### **TUALATIN ARCHITECTURAL REVIEW BOARD**

**April 9, 2014, 7:00 PM**

- A. Southwest Industrial Park Recommendation and Staff Report for AR-14-02

**C2.1**

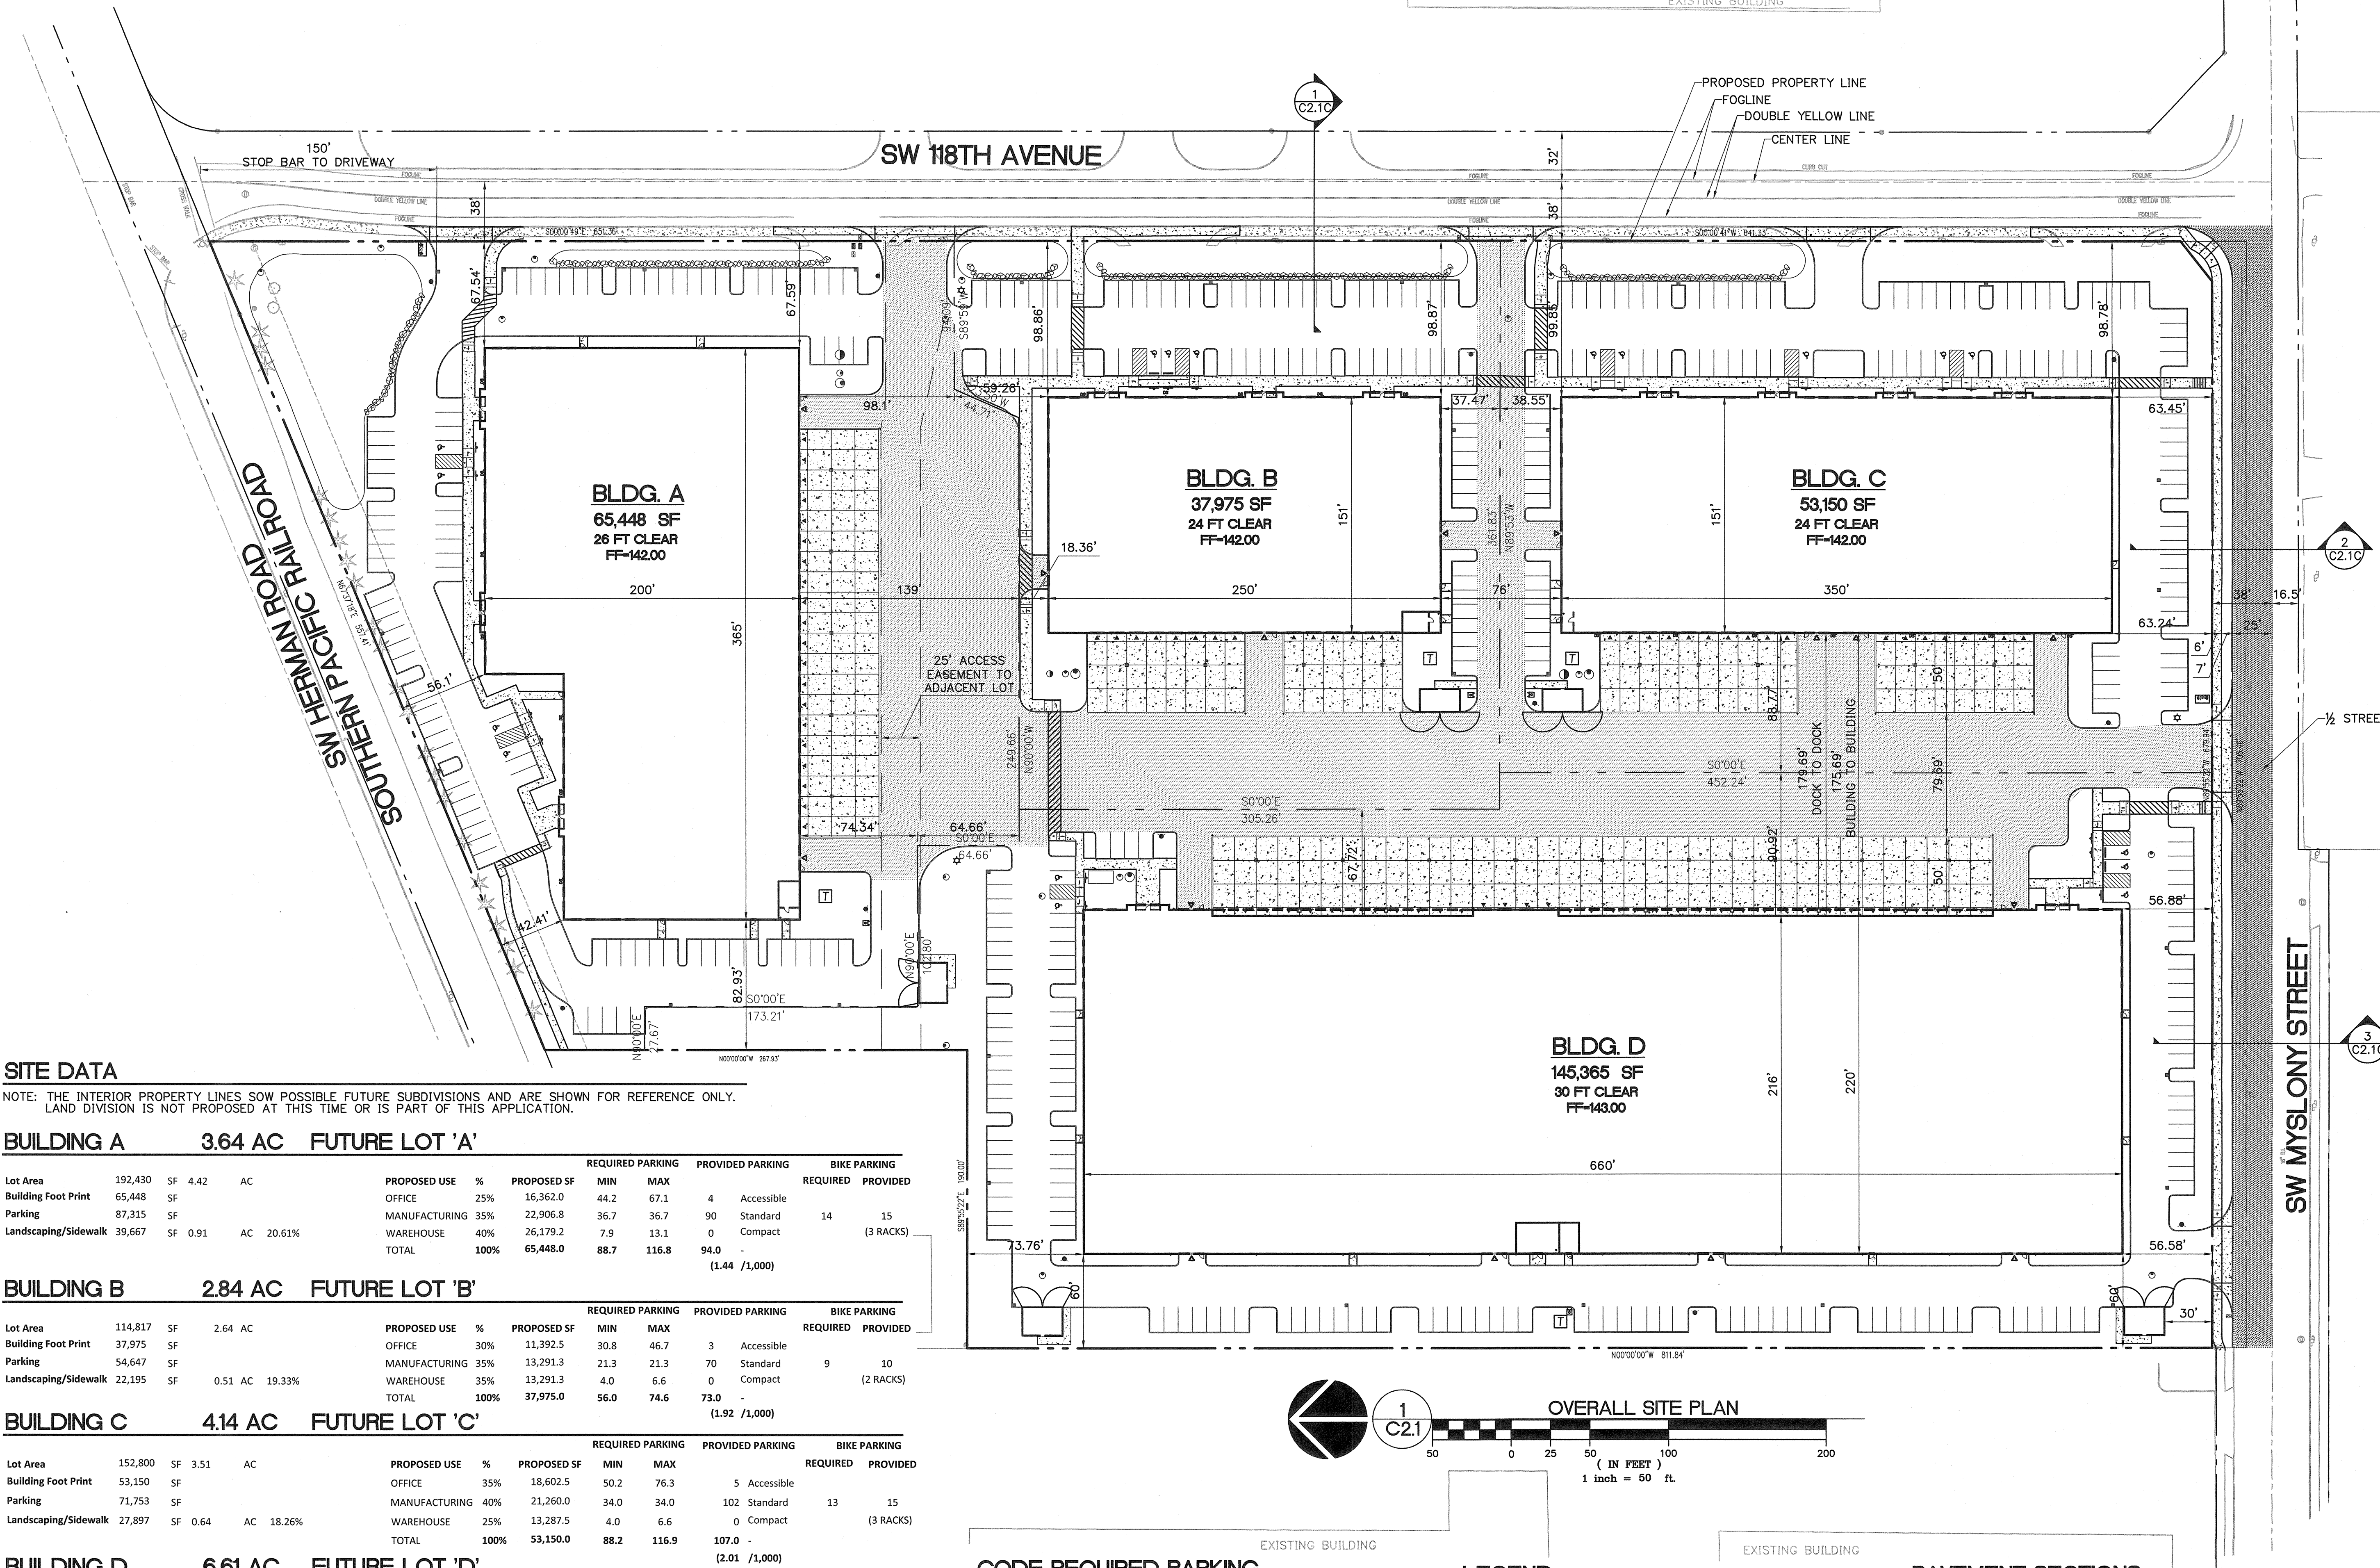
Based on the above definitions and the overall site plan (Sheet C2.1) included within the site plans within the application materials (Attachment 104), possible future lot measurements are:

Based on the above definitions and the overall site plan (Sheet C2.1), the setbacks are:

The overall site plan (Sheet C2.1) indicates that each of Buildings A-D has a walkway connection from the building entrance to a sidewalk in a public ROW and that each connection varies from five (5) to eight (8) ft wide, meeting the requirement.

The overall site plan (Sheet C2.1) indicates that each walkway crossing has a different appearance than the adjacent paved vehicular areas through paint striping, meeting the requirement.

The overall site plan (Sheet C2.1) proposes 407 parking spaces across Lots A-D of which none is compact, and no parking aisles exceed 8 continuous spaces in a row without a landscaped island, meeting the requirements.

## C2.1B

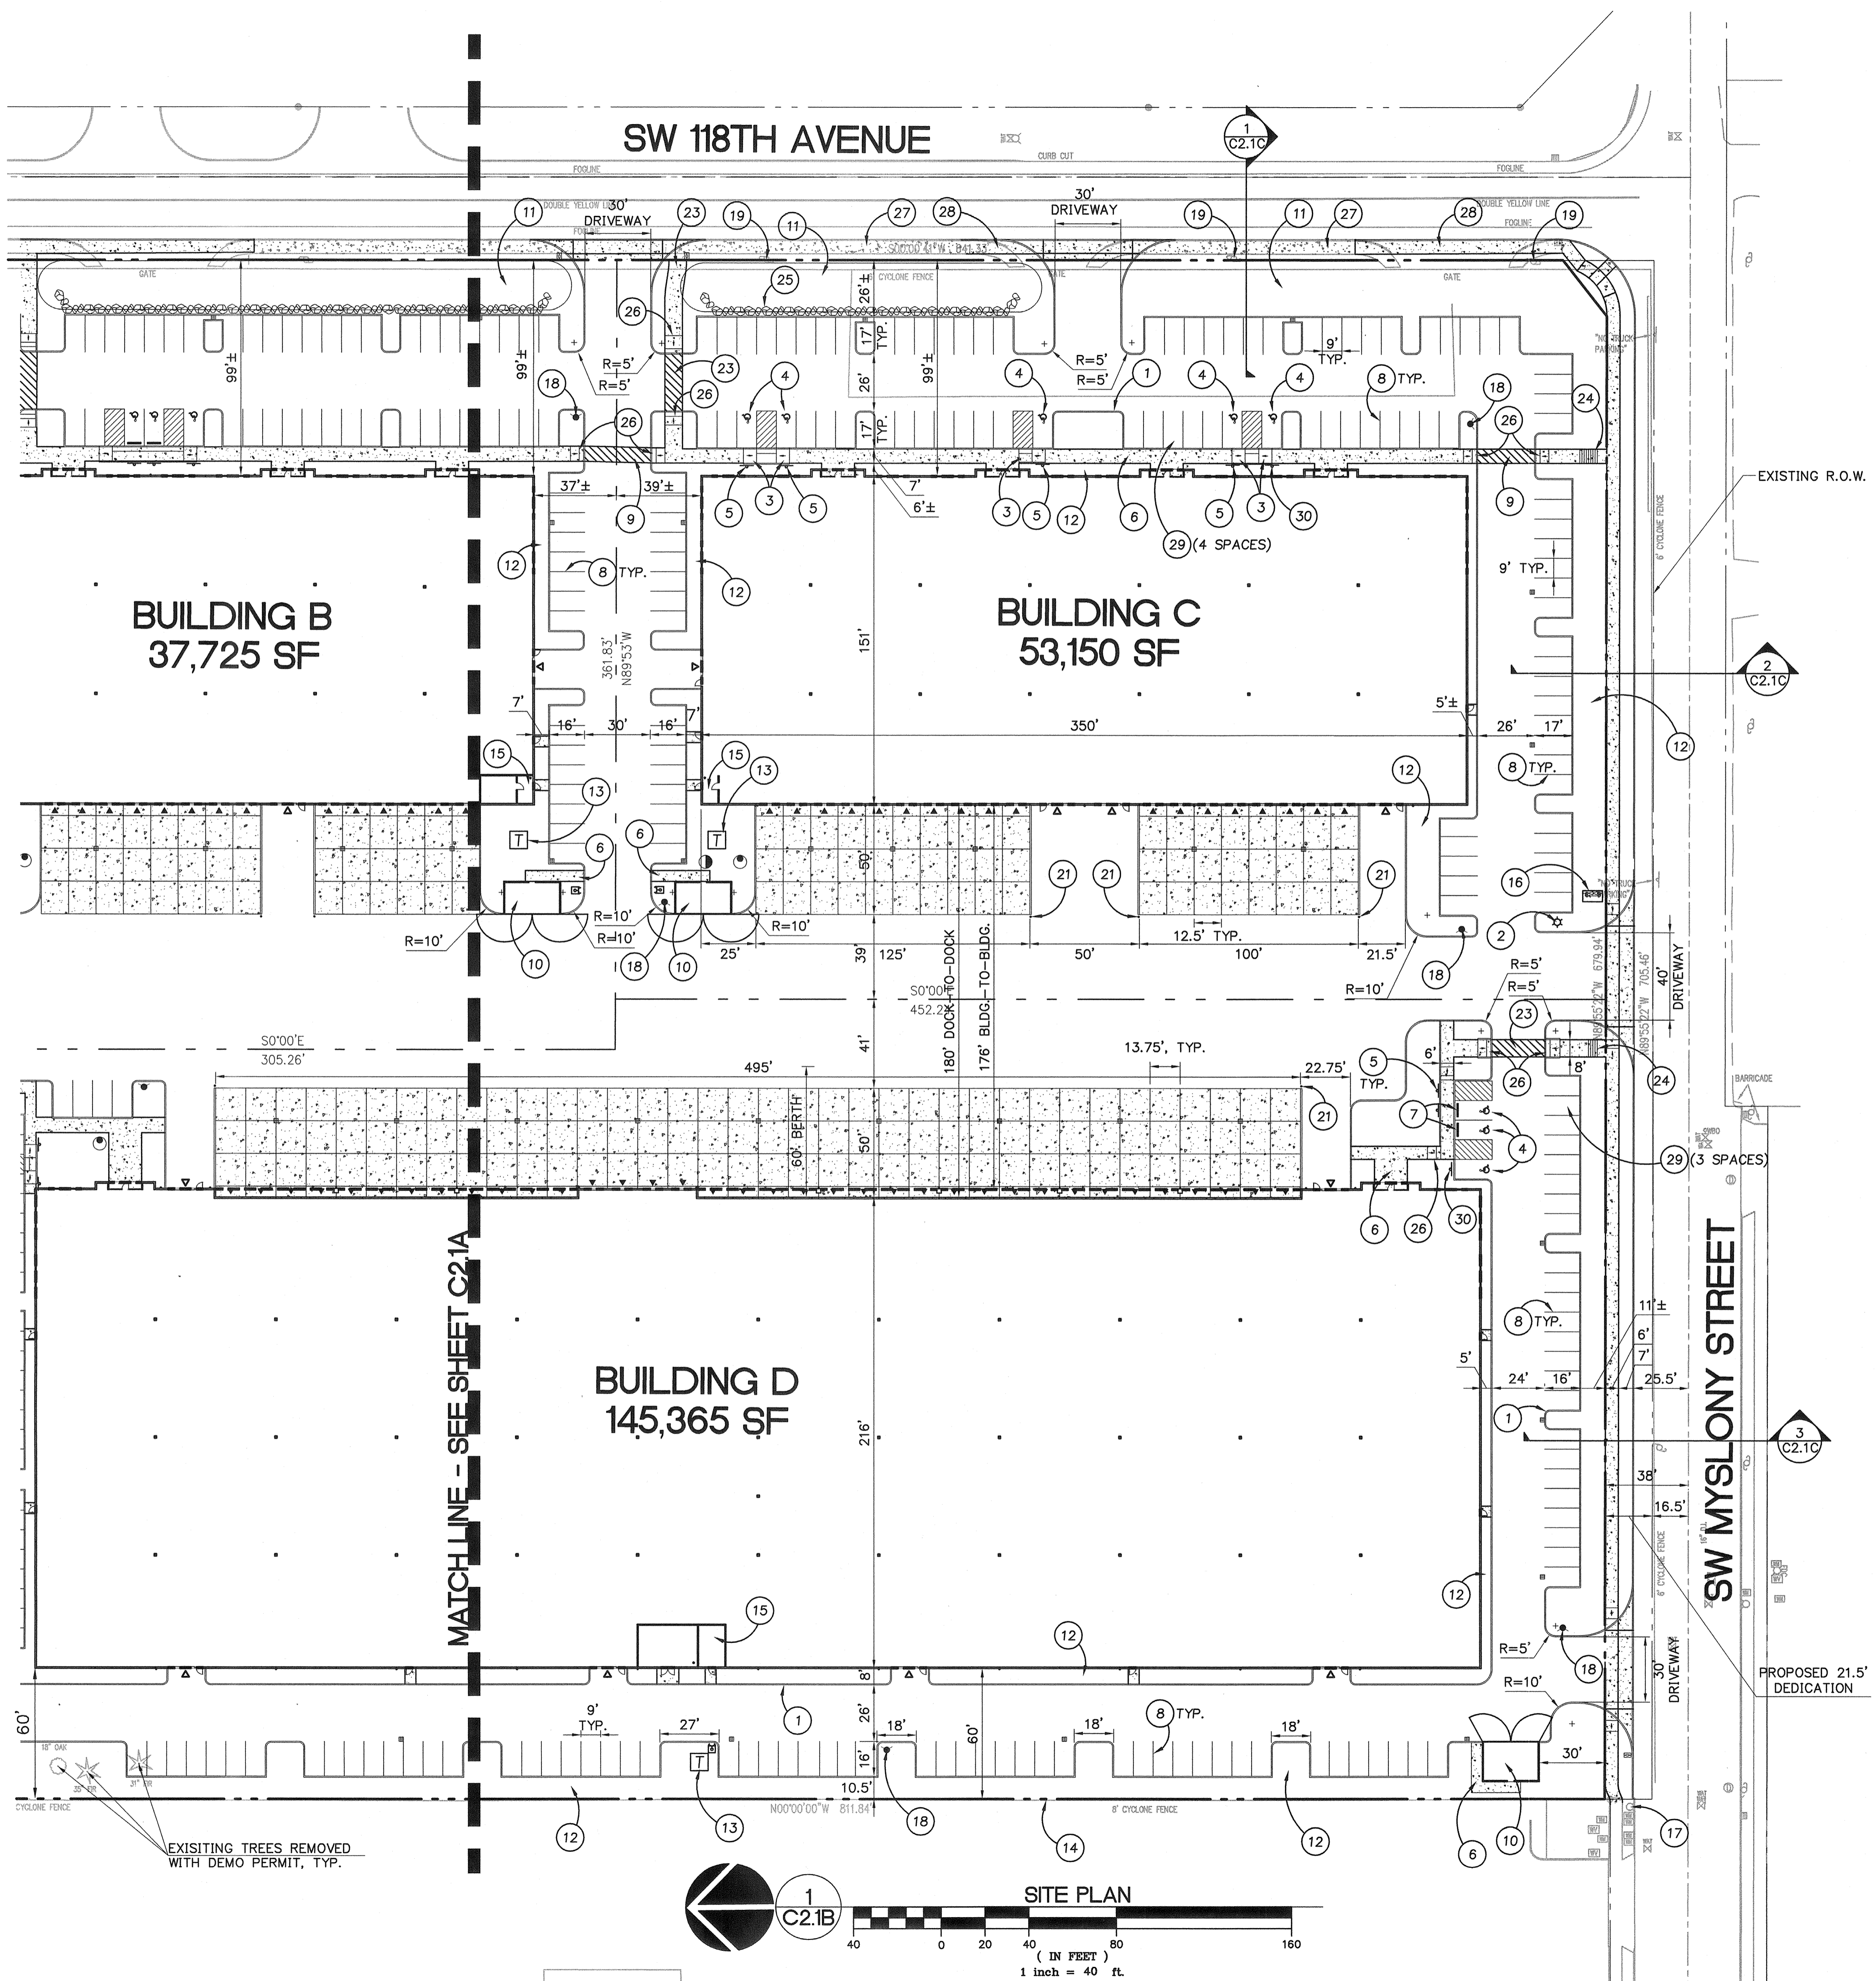
The site plans north and south (Sheets C2.1A and C2.1B) illustrate that each of Buildings A, B, and D have accessways from building perimeter walkways to public sidewalks.

The site plans north and south (Sheets C2.1A and C2.1B) illustrate that all walkway and accessways between buildings and public sidewalks that cross curbs have curb ramps. The plans propose 5 trash enclosures, one each for Buildings A-C and two for Building D. Each has a walkway leading from a drive aisle to a pedestrian entry at the rear of an enclosure. The applicant needs to install a curb ramp at each of the 5 interfaces of trash enclosure walkways and drive aisle curbs. Staff recommends this as a condition of approval.

The site plans north and south (Sheets C2.1A and C2.1B) illustrate and note 8-foot accessways, which are private, constructed of asphalt and concrete and ADA compliant, meeting the requirement.

First, the site plans identify 28 total existing trees on Lot 1200, not 23 as the narrative states, all of which are reflected in light gray on the site plan north (Sheet C2.1A) on what will be Lots A and D. Second, staff disagrees that removal of every tree is necessary to "ensure the most efficient use of the site" and that existing trees "do not blend with the surrounding and proposed landscaping", neither reason being a tree removal criterion. "Damage during construction due to their proximity to grading and improvements of the proposed development" is reasonable; however, the application lacks enough specific information to demonstrate this reason applies to all 26 trees. Third, the applicant can revise the site plans to make more feasible preservation of certain trees while retaining efficient use of the site. This is outlined below.

Additionally, the applicant can revise the plans to increase the distance between certain trees and improvements. Specifically, regarding Trees A20-A24 and D1-D2, narrowing the adjacent drive aisles from the proposed 26 ft to 22 ft gains 4 additional feet between drive aisle and curbing and these trees. This is feasible because the two adjacent drive aisle widths are in excess of the 22 ft required by 73.380(11) below. Additionally, the applicant can propose less deep parking spaces as compact parking spaces, which Figure 73-1 allows to have a stall depth of 15 ft. The applicant can also shift the proposed walkway adjacent to Trees A20-25 away from them along with the drive aisle.
